# Access Compliance Report

## Public Rights-of-Way

### (Curb Ramps)

Intersection ID: 10021318	Main Street: BLAKENEY_DR	Cross Street: N/A	Location: NE
ADA ID: 54DB576AFBDE	Ramp Type: BlendTrans1	Initial Pass/Fail: Fail	Overall Compliance: No
		Severity Score: 12.5

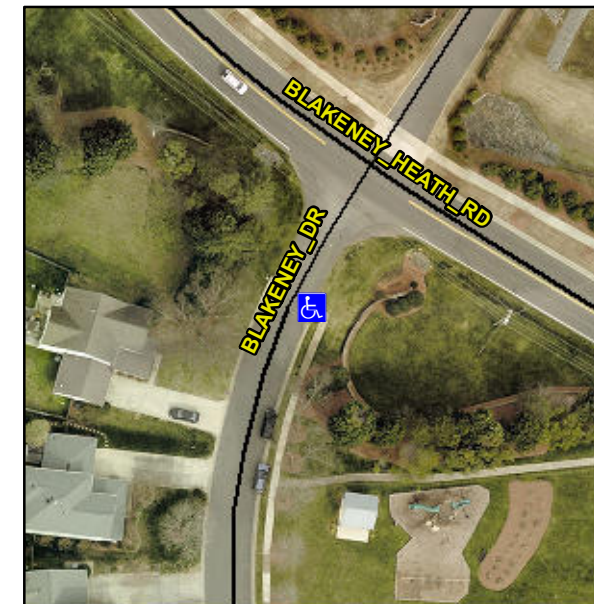
**Not Found, R304.5.3**

Compliance	Description	Data	Compliance	Description	Data
N/A	Ramp Length (in)	96.0	Yes	BlendTrans Slope (%)	4.4
Yes	Ramp Width (in)	48.0	No	BlendTrans XSlope (%)	5.3
N/A	Flare Type LT	N/A	N/A	Flare Type RT	N/A
N/A	Flare Slope LT (%)	N/A	N/A	Flare Slope RT (%)	N/A
N/A	Flare Traversable LT?	N/A	N/A	Flare Traversable RT?	N/A
N/A	Landing Length (in)	N/A	N/A	DWS Provided?	N/A
N/A	Landing Width (in)	N/A	N/A	DWS Contrast?	N/A
N/A	Landing Slope (%)	N/A	N/A	DWS Length (in)	N/A
N/A	Landing X Slope (%)	N/A	N/A	DWS Full Width?	N/A
N/A	Landing Curb? (Y/N)	N/A	N/A	DWS Offset (in)	N/A
N/A	Shared Landing?	N/A			
N/A	Gutter Ponding?	N/A	N/A	Gutter Slope (%)	N/A
N/A	Gutter Lip Ht (in)	N/A	N/A	Gutter X Slope (%)	N/A
N/A	Painted X Walk1?	No	N/A	Painted X Walk2?	N/A
	X Walk 1 Direction	To SW		X Walk 2 Direction	N/A
	X Walk 1 Width (in)	N/A		X Walk 2 Width (in)	N/A
	X Walk 1 Slope (%)	3.4		X Walk 2 Slope (%)	N/A
	X Walk 1 X Slope (%)	5.4		X Walk 2 X Slope (%)	N/A

N/A	Ramp inside XWalk1?	N/A	N/A	Ramp inside XWalk2?	N/A
	Road Slope (%)	5.4		Clear Space?	N/A
	Road X Slope (%)	3.4	N/A	Clear Space to XWalk (in)	N/A
N/A	Any Obstructions?	N/A	N/A	Storm Grate/Utility Hazard?	N/A
	Obstruction Type			Storm Grate/Utility Type	
		N/A			N/A
			Yes	Surface Condition? (G/P)	Good
			No	Curb Slope (%)	21.6

**Remove & Replace Curb Ramp With Two New Directional Ramps or Equivalent.**
